# PROJECT REVIEW REPORT

<b>Project ID</b>	2709
<b>Project Name</b>	Jurena River REDD+ Project
<b>Review Type</b>	Registration & Verification Approval
<b>Program(s)</b>	VCS Program
<b>Verification Period</b>	12 Nov 2020 – 31 Dec 2021
<b>Project Proponent</b>	Ecológica Assessoria Ltda (original submission) Beatris Tormena Fabris Gradela Ltda. (change in Project proponent after third issue of PRR)
<b>Methodology</b>	VM0015, v1.1
<b>VVB</b>	Earthood Services Private Limited
<b>Assessment Criteria</b>	VCS Standard, v4.3
<b>Date of First Issue</b>	20 Jan 2023
<b>Date of Second Issue</b>	27 Sep 2023
<b>Date of Third Issue</b>	15 April 2024

Figure: new set of 'weights of evidence', after including authorized management plans in the spatial allocation model.

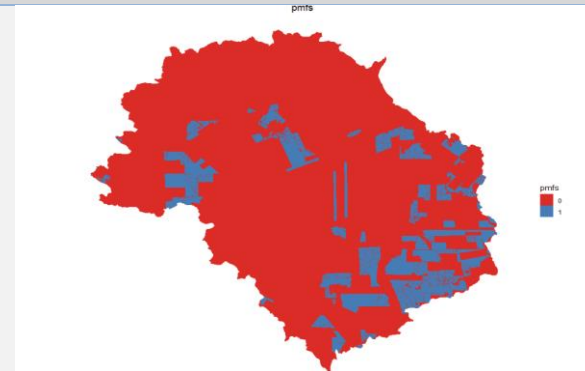
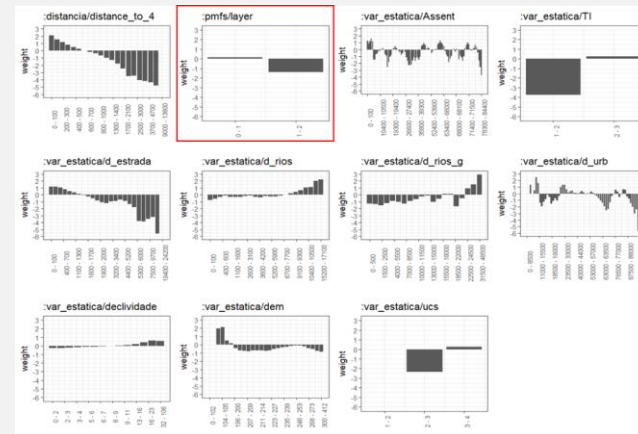
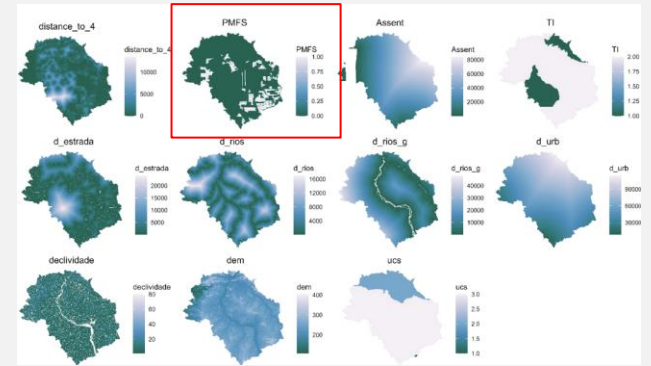
12	Unclear if historical planned deforestation was excluded in the reference region
	<p>indicator for analysis.</p> <p><u>Verra Response</u> The finding cannot be closed.</p> <p><u>Issue</u></p> <ol style="list-style-type: none"> <li>1. It remains unclear if in the RR during the historical reference period, deforestation dynamics were similar in areas under SFM and areas without SFM.</li> </ol> <p><u>Action required</u></p> <ol style="list-style-type: none"> <li>1. The VVB must ensure the PP demonstrates with verifiable evidence that in the RR, historical deforestation dynamics are similar in areas with and without SFM.               <ol style="list-style-type: none"> <li>a. If deforestation in areas without SFM have higher deforestation rates than areas with SFM, the spatial model must be adjusted to reflect the difference. See background section below,</li> </ol> </li> <li>2. The VVB must ensure that the PD is updated to include any modification in the baseline GHG emissions calculations.</li> <li>3. The VVB must assess the revised PD and update the VR accordingly.</li> </ol> <p><u>Background</u></p> <ol style="list-style-type: none"> <li>1. Section 3.5 states that “<i>Many scientific articles</i></li> </ol>

12	Unclear if historical planned deforestation was excluded in the reference region	<p>conclude that <b>sustainable forest management plans (SFMP)</b>, namely those certified, can be considered a tool for forest conservation, maintenance of forest carbon stocks, and <b>decrease of deforestation rates</b> in the region where they are implemented.”</p> <ol style="list-style-type: none"> <li>2. A new variable may be tested and added to the spatial model (if significant) to illustrate the impact of the “presence/absence of a SFMP”. This variable does not have to be added if it can be demonstrated with verifiable evidence that historical deforestation was similar in both areas with and without SFM.</li> <li>3. In the PRR response the project argues that “per the deforestation authorizations (AD), <b>the small approved portion does not significantly contribute to the deforestation</b> observed in the RR” without reporting evidence and statistics to support the statement. Additionally, the sentence “it becomes evident that <b>deforestation</b> within the reference region <b>is not exclusively of areas covered by authorizations</b>” implies that part of the historical deforestation is covered by legal authorization, which must be measured and differentiated from illegal deforestation.</li> </ol>

12	Unclear if historical planned deforestation was excluded in the reference region
	<p>analysis were adjusted to evaluate the historical dynamics of deforestation in areas with and without SFM:</p> <p>After further analysis, it was verified that the presence of a forest management plan has a negative impact on deforestation (decreasing its likelihood). In the analysis, a new variable was included in the model, “PMFS”, which is a binary map with unit values representing forest areas with active AUTEX authorizations. Weights of evidence for these areas are statistically lower, according to analysis. As timber logging also occurs inside the project area, the project proponent performed a new spatial analysis to avoid overestimating the baseline.</p> <p>The VVB reviewed the geoportal data used and geographic analysis.</p> <p><i>Figure: Location of authorized management plans in the reference region. Areas of forest with an active management plan are the areas in blue.</i></p> <p><i>* This figure is not included in the PD&amp;MR v14 considering that it is one of several variables included in the model and it is deforestation covered by legal authorizations, however, it is included in response to Verra's finding, as it is the result of the spatio-temporal analysis performed.</i></p>

\* This figure is included in section 3.4 of PD&MR v14 as figure 62, being evidence of the inclusion of the variable "pmfs" to the model.

63, being evidence of the inclusion of the variable "pmfs" to the model.

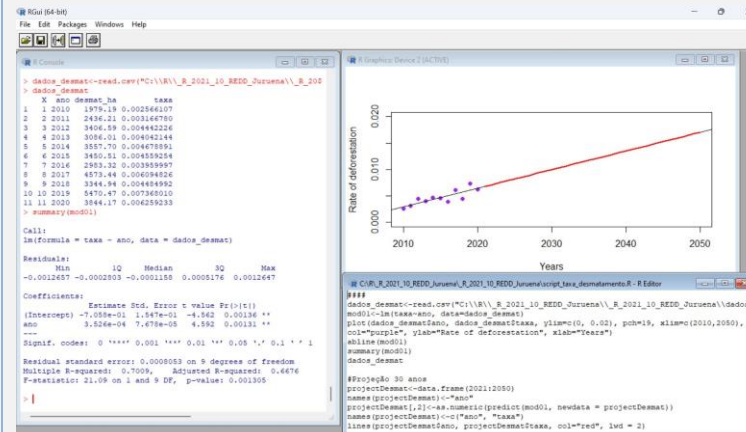
<b>15</b>	<b>Insufficient justification for the time function approach</b>			
	<p><u>Issue</u> The analysis of agents and drivers does not conclusively establish an increasing trend in deforestation rate; therefore, the time function approach is not applicable.</p> <p><u>Action required:</u></p> <ol style="list-style-type: none"> <li>The VVB must ensure that future deforestation is projected using the historical average approach unless it can be <u>clearly demonstrated</u> that conclusive evidence emerges from the analysis of agents and drivers explaining the increasing trend and making it likely that this trend will continue in the future. The VVB must ensure that any changes made to the baseline are reflected in the calculations and in all impacted sections.</li> <li>The VVB must assess the revised joint PD/MR and update the joint VR accordingly.</li> </ol>	<table border="1"> <tr> <td style="background-color: #1a3d4d; color: white;"><b>Round 1</b></td> </tr> <tr> <td> <p><u>VVB Response</u> The project proponents have updated the joint PD/MR, which analysis of agents and drivers is developed in accordance with the requirements and statements of VM0015 and is supported by secondary and spatial information. The changes were evaluated by the VVB and the corresponding analysis was included in section 3.3.5 of the validation report.</p> <p><u>Verra Response</u> The finding cannot be closed. The PD/MR was updated with sufficient information to justify the time function approach, but inconsistencies remain.</p> <p><u>Issue</u></p> <ol style="list-style-type: none"> <li>In Section 4.1 of the joint PD/MR (pg. 119), the equation describing the linear trend in deforestation rate over time is not consistent</li> </ol> </td> </tr> </table> <p style="text-align: right;">Closed</p>	<b>Round 1</b>	<p><u>VVB Response</u> The project proponents have updated the joint PD/MR, which analysis of agents and drivers is developed in accordance with the requirements and statements of VM0015 and is supported by secondary and spatial information. The changes were evaluated by the VVB and the corresponding analysis was included in section 3.3.5 of the validation report.</p> <p><u>Verra Response</u> The finding cannot be closed. The PD/MR was updated with sufficient information to justify the time function approach, but inconsistencies remain.</p> <p><u>Issue</u></p> <ol style="list-style-type: none"> <li>In Section 4.1 of the joint PD/MR (pg. 119), the equation describing the linear trend in deforestation rate over time is not consistent</li> </ol>
<b>Round 1</b>				
<p><u>VVB Response</u> The project proponents have updated the joint PD/MR, which analysis of agents and drivers is developed in accordance with the requirements and statements of VM0015 and is supported by secondary and spatial information. The changes were evaluated by the VVB and the corresponding analysis was included in section 3.3.5 of the validation report.</p> <p><u>Verra Response</u> The finding cannot be closed. The PD/MR was updated with sufficient information to justify the time function approach, but inconsistencies remain.</p> <p><u>Issue</u></p> <ol style="list-style-type: none"> <li>In Section 4.1 of the joint PD/MR (pg. 119), the equation describing the linear trend in deforestation rate over time is not consistent</li> </ol>

the two software programs. Despite the differences in the equations between the two tools, the results are equivalent because the value of the adjusted R<sup>2</sup>, which indicates the percentage of prediction error eliminated in variable y when using least-squares regression on variable x, is the same (0.6). The outcomes and script for the linear regression analysis in “R” are presented as follows:

Figure 60. Deforestation rate in the reference region<sup>1</sup> during the HRP and future projections<sup>2</sup> up to 2050.

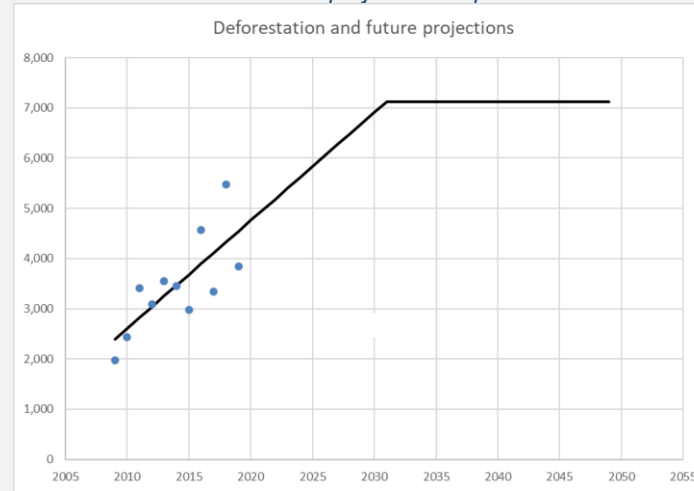
15	Insufficient justification for the time function approach		
		<p><u>Issue</u></p> <ol style="list-style-type: none"> <li>1. The linear regression using R Studio and presented in figure 60, Section 4.1 of the Joint PD/MR is built on different data points and does not include the entire historical reference period presented in the excel calculation spreadsheet, “Table 8 RR projection” (see background section).</li> </ol> <p><u>Action Required</u></p> <ol style="list-style-type: none"> <li>1. The VVB must ensure that Section 4.1 of the Joint PD/MR is updated to include the correct deforestation rate data in figure 59, reporting the correct linear equation and its statistical fit (i.e. R<sup>2</sup>).               <ol style="list-style-type: none"> <li>a. If this revision leads to different values of future deforestation, the updates must be described and reflected also in the PD and MR calculation spreadsheets.</li> <li>b. If this revision leads to a linear trend that does not meet statistical good practices, the VVB must raise a FAR requiring new validation of the baseline for the next verification period (see background section).</li> </ol> </li> </ol> <p><u>Background</u></p> <ol style="list-style-type: none"> <li>1. Difference between Figure 59 of the Joint PD/MR and “Table 8 RR projection” of the PD calculation sheet:</li> </ol>

15	Insufficient justification for the time function approach		
		<ul style="list-style-type: none"> <li>a. The first data point in the excel sheet (2009, 0.32%) is not included in the equation presented in figure 59, which begins from the second data point (2010, 0.26%)</li> <li>b. The last data point in figure 59 (2019, 0.63%) is incorrect compared with the excel sheet (2019, 0.52%).</li> </ul> <p>When these points are corrected, the linear equation appears to have different statistical fit (i.e. R<sup>2</sup>) than what is reported in Section 4.1 of the Joint PD/MR and leads to more conservative estimates of future deforestation rate in the RR compared with the results in the excel.</p> <ul style="list-style-type: none"> <li>2. Deforestation that occurred in the RR during the verification period has been monitored ex-post. This additional evidence has been provided to confirm the projected increase in deforestation rate is representative of what happened in the RR during the current monitoring report. While this may be deemed sufficient to close this verification request, it is insufficient to validate the baseline. The project must transition to VM0048 starting from the next verification and revalidate the baseline for 6 years.</li> </ul>

15	Insufficient justification for the time function approach	
		<p>1. The VVB reviewed the adjustments in section 3.4 of the joint PD&amp;MR v14 and in the VCS PD Calculation_Juruena River REDD_Project_v12 spreadsheet to ensure the linear regression data consistency over the defined historical reference period. The project proponent corrected the data point of 2020. The data point of 2009 was not included because deforestation in each year covers the period of November 12 to November 11, i.e., the data point of 2010 corresponds to deforestation that occurred between November 12, 2009, to November 11, 2010.</p> <p>The VVB ensured that the regression model and predictions had been adjusted accordingly. The project proponent fitted a new regression model on absolute deforestation rates and calculated the <i>toptimal</i>, <i>taverage</i> and <i>tsuboptimal</i> according to section 4.1.2.1 of the VM0015 1.1 methodology.</p> <p>The statistical fit (<math>R^2 = 0.5137</math>) indicates the model explains more than 50% of the variability of annual deforestation rates in comparison with a simple historical average. This is an expressive amount of variability. Besides, the p-value (0.8%) is very low, indicating that the observed trend is statistically significant and unlikely to be due to chance.</p> <p>The resulting projections are shown in the Figure below and all details are included in the revised PDD:</p>

The VVB verified that the statistical results lead to reliable values of future deforestation and that the model accounts for variability in annual deforestation rates compared to a simple historical average. Therefore, it can be concluded from these results that the model fits deforestation rates significantly better than the historical average.
